ADDENDUM No. 1

November 03, 2023

RE: Interior Remodel to Create EHS Office Area - Elliott – Wagoner Building
Ball State University
BSU Project No. 2023 – 032.01 EW

ARCHITECTURAL FLOOR PLAN

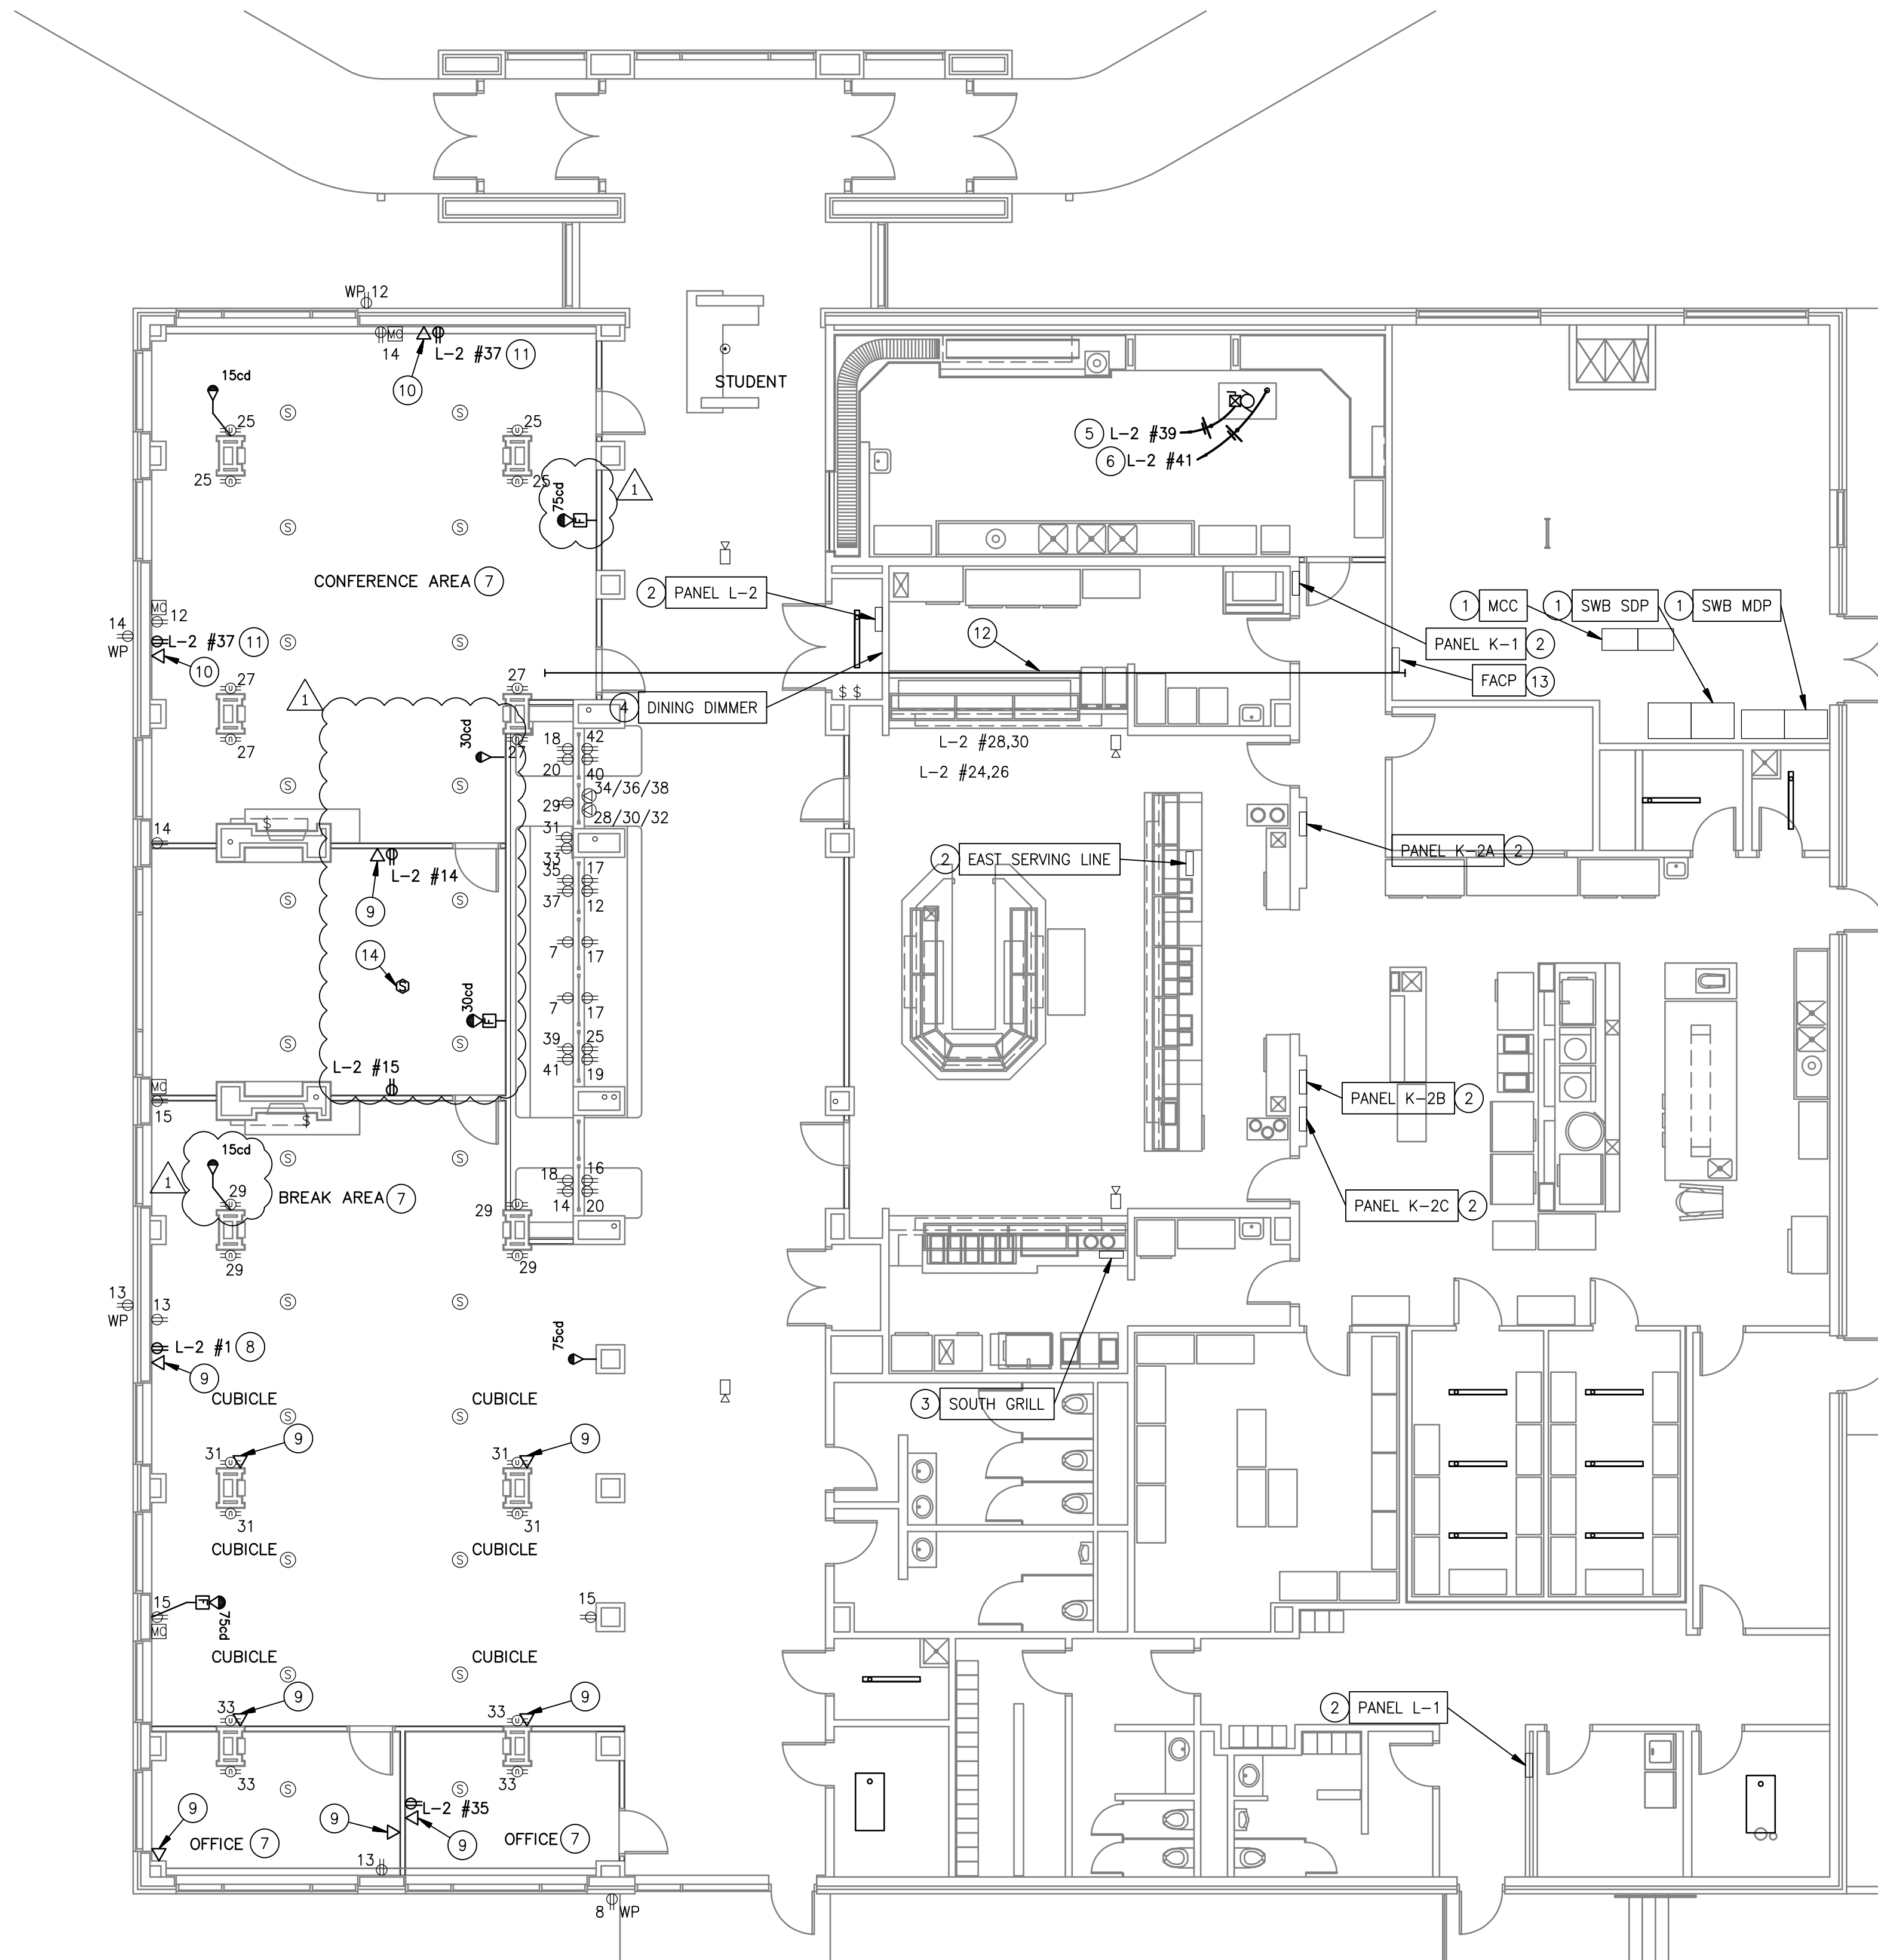
3. Sheet A101 – Architectural Floor Plan
 - a. This sheet has been Reissued as part of this Addendum.
 - b. Add additional Wall and Door at the Northern existing fireplace located in the “Conference Area” to create new space. Refer to Reissued drawing sheet A101 for location.

- c. Contractor to install new carpet that matches existing pattern(s), color(s), and orientation(s). Refer to Reissued drawing sheet A101 for location.

- d. Add Plan Note No. 8 that states “Infill opening at existing tray return (paint).” Refer to Reissued drawing sheet A101 for location.
4. Sheet A102 – Reflected Ceiling Plan

- WITHIN HATCHED AREA - INSTALL NEW CARPET THAT MATCHES EXISTING PATTERN(S), COLOR(S) AND ORIENTATION(S)
- EXISTING BEVERAGE SERVICE IS TO BE PARTIALLY ENCLOSED BY NEW WALL CONSTRUCTION. - COORDINATE WITH OWNER TO ENSURE ALL KITCHEN EQUIPMENT HAS BEEN REMOVED AND / OR PROPERLY PROTECTED

- INFILL EXISTING TRAY RETURN OPENING (PAINT)

ELECTRICAL
POWER AND
SYSTEMS
PLAN

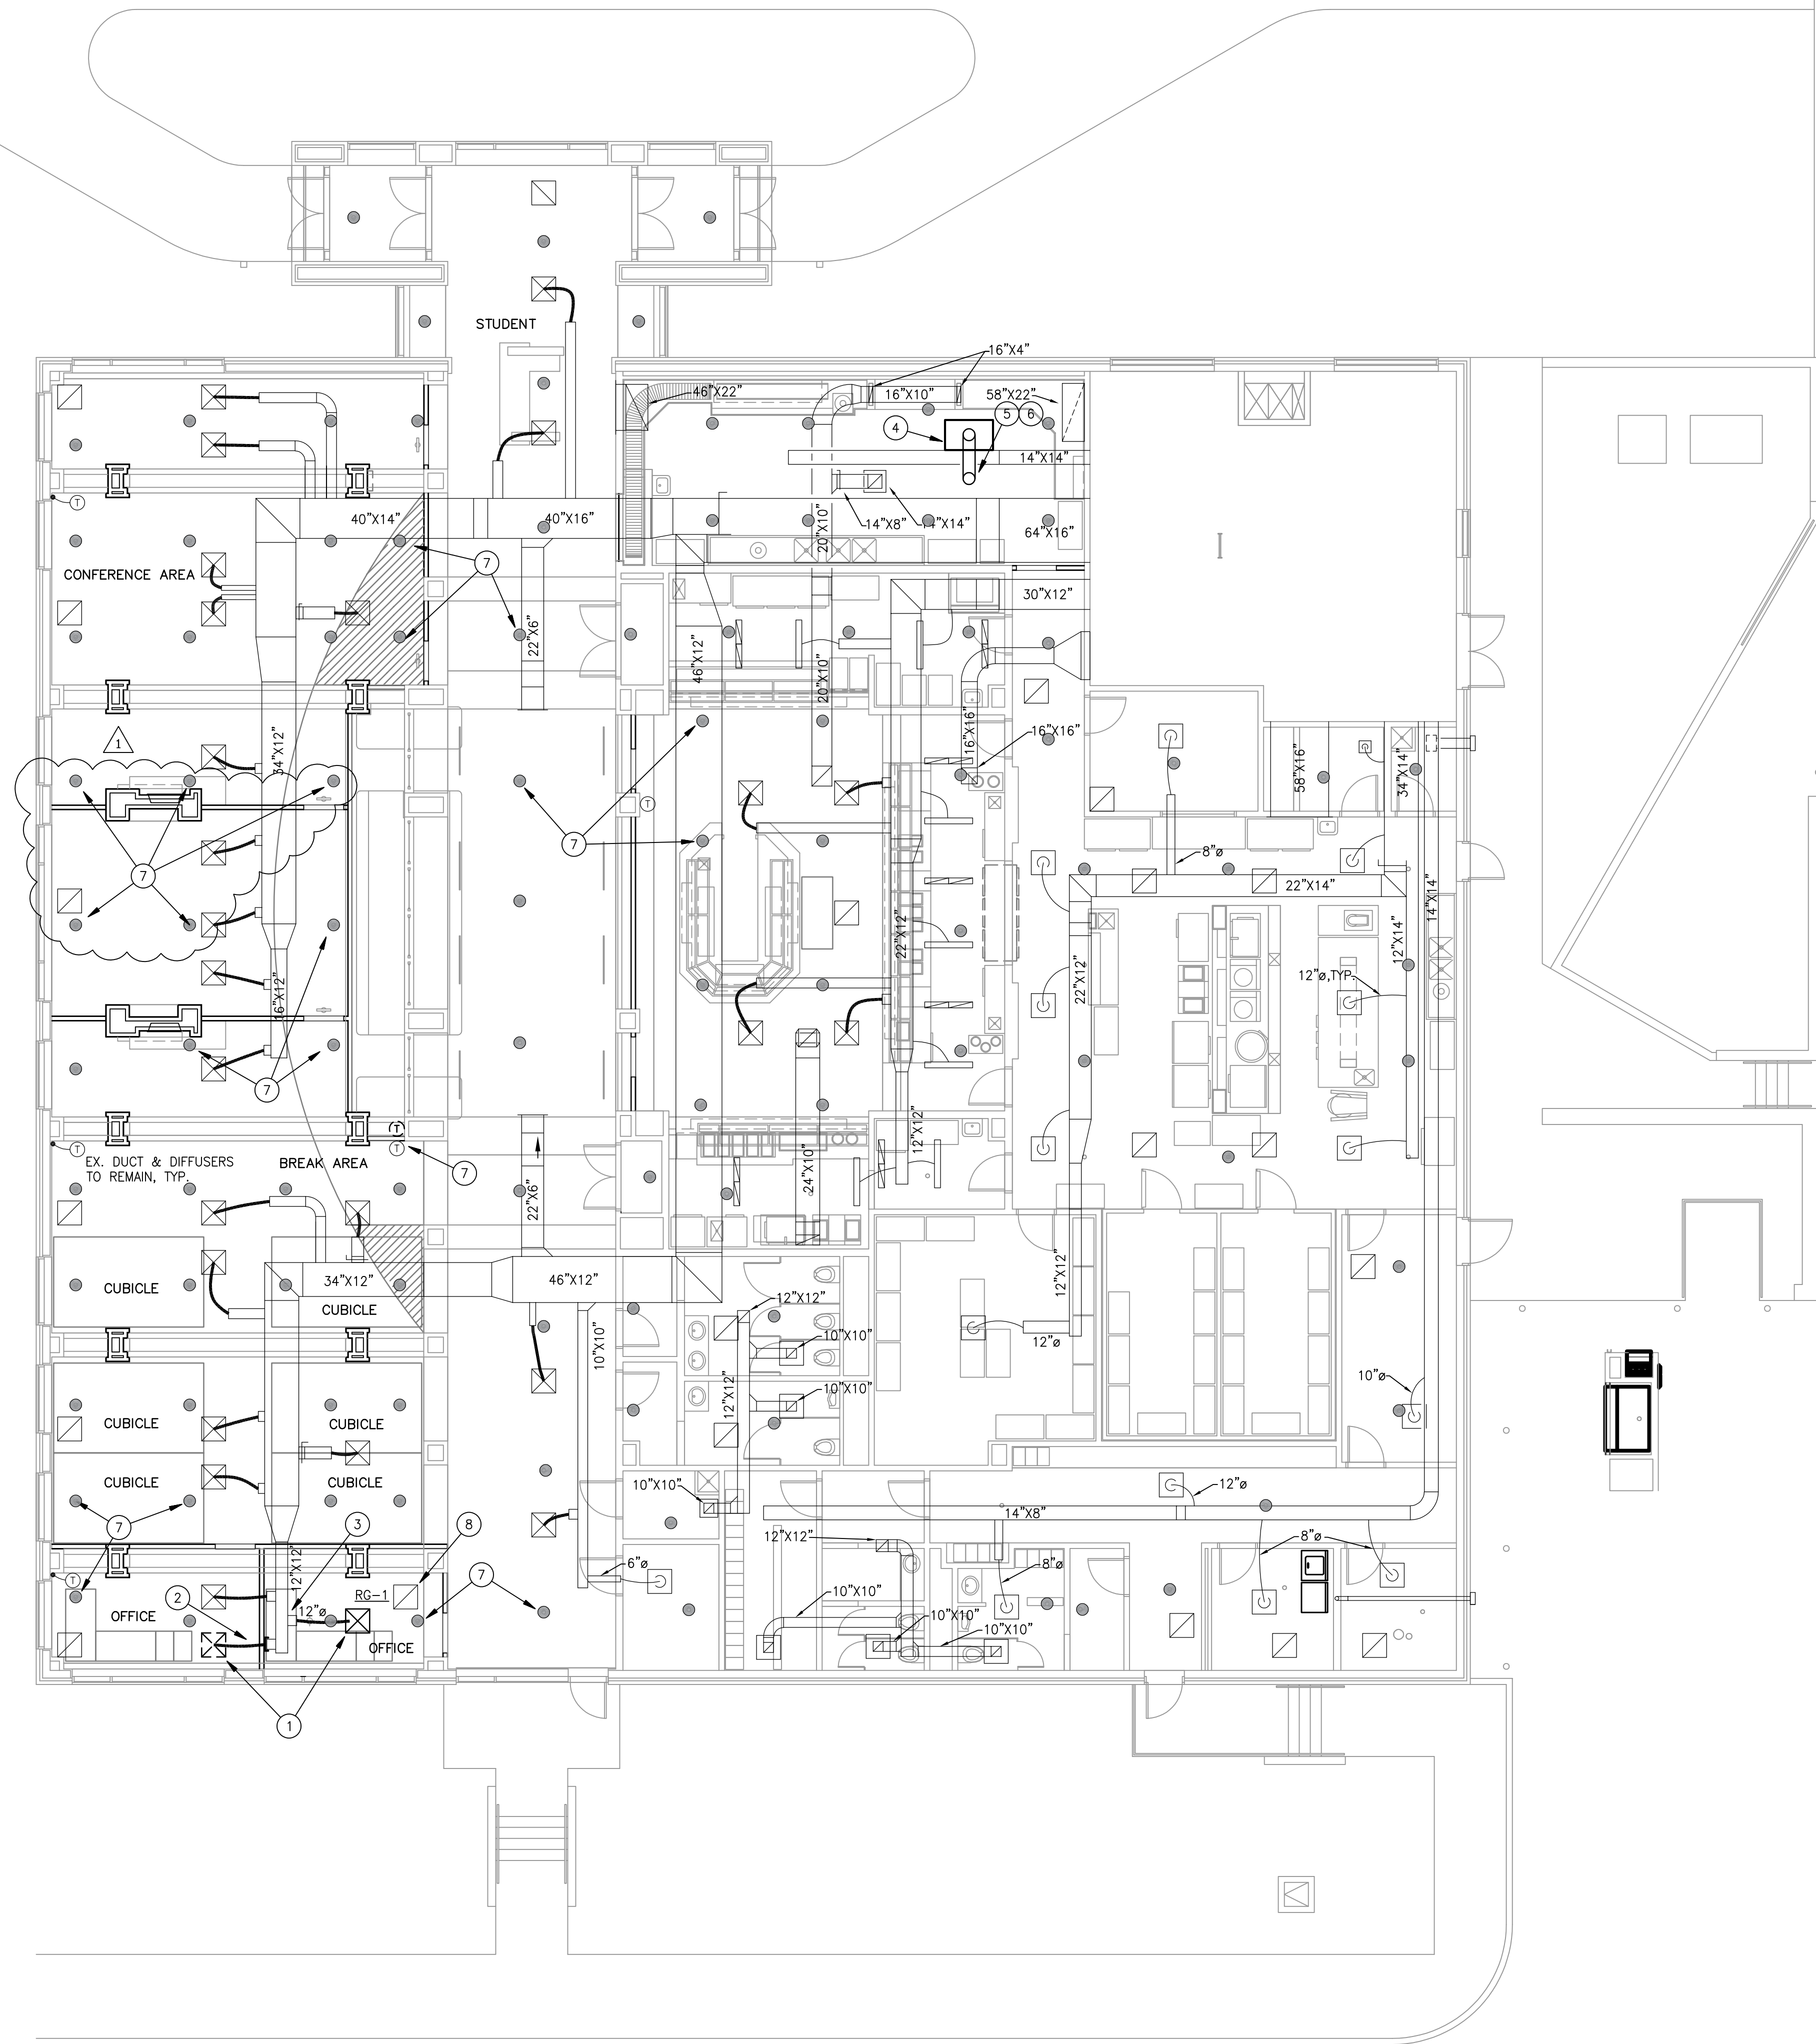
- 8. Sheet E301 – Electrical Power and Systems Plan
 - a. This sheet has been Reissued as part of this Addendum.

- PROVIDE (1) 2" EMT ABOVE CEILING FOR TELECOM CABLE PATHWAY.
- EXISTING FIRE-LITE #MS-9600 FIRE ALARM CONTROL PANEL (FACP) TO REMAIN.
- PROVIDE NEW FIRE ALARM CEILING MOUNTED SMOKE DETECTOR.
